ECN/PCN No.: 4266

For Manufacturer			
Product Description: SMD VC/TCXO	Abracon Part Number / Part Series: ASVTX-12/ASTX-12	<input type="checkbox"/> Documentation only	<input checked="" type="checkbox"/> Series
		<input checked="" type="checkbox"/> ECN	<input type="checkbox"/> Part Number
Affected Revision: J	New Revision: K	<input type="checkbox"/> EOL	
		Application:	<input type="checkbox"/> Safety <input checked="" type="checkbox"/> Non-Safety

ASTX-12/ASVTX-12 Rev. J

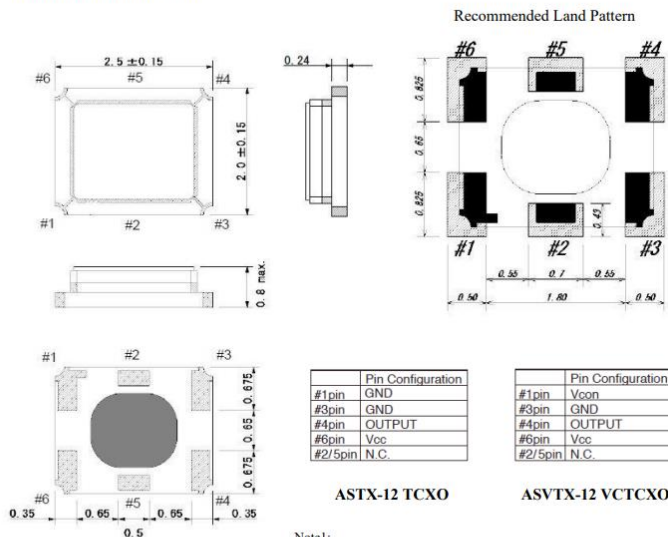
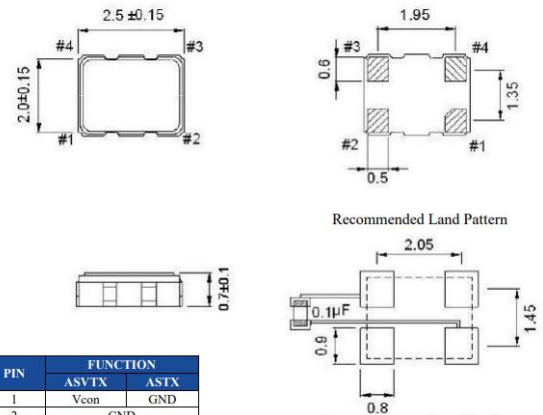
Prior to Change:

7.0 Mechanical Dimensions 1

It is recommended that a by-pass capacitor of 0.01uF value be placed between pin #6 and pin #3 and an AC-coupling capacitor of the same value be placed in series with pin#4 for optimal performance.

For ASTX, please connect pin #1 and #3 to GND.

Pin#2 and Pin#5 should be left floating (No Connect = N.C.)

Discontinuation of the 6 pad package configuration.

ASTX-12/ASVTX-12 Rev. K

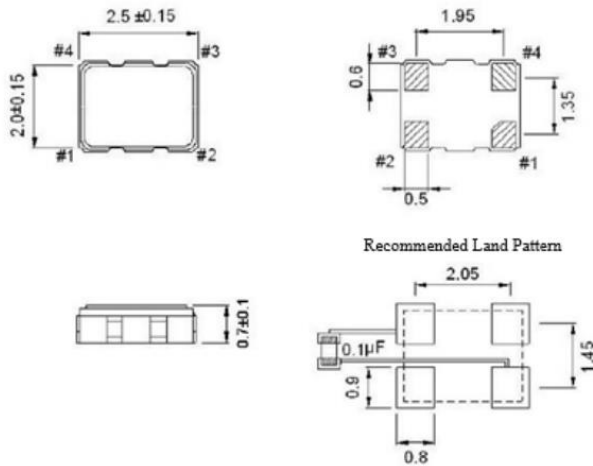
After Change:

Packaging
T3: 3,000pcs/reel

PIN	FUNCTION	
	ASVTX	ASTX
1	Vcon	GND
2	GND	
3	OUTPUT	
4	Vcc

It is recommended that a by-pass capacitor of 0.1 μ F value be placed between pin #2 and pin #4 and an AC-coupling capacitor of the same value be placed in series with pin#3 for optimal performance.
